PIC18F2410/2510/4410/4510 Rev. B4 Silicon Errata

The PIC18F2410/2510/4410/4510 Rev. B4 parts you have received conform functionally to the Device Data Sheet (DS39636D), except for the anomalies described below. Any Data Sheet Clarification issues related to the PIC18F2410/2510/4410/4510 will be reported in a separate Data Sheet errata. Please check the Microchip web site for any existing issues.

FIGURE 1: SCK PULSE VARIATION USING TIMER2/2

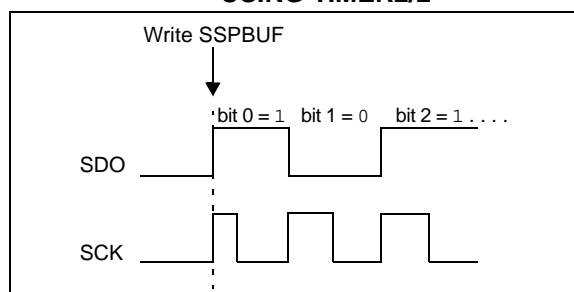
When the SPI is using Timer2/2 as the clock source, a shorter than expected SCK pulse may occur on the first bit of the transmitted/received data (Figure 1).

To avoid producing the short pulse, turn off Timer2 and clear the TMR2 register, load the SSPBUF with the data to transmit and then turn Timer2 back on. Refer to Example 1 for sample code.
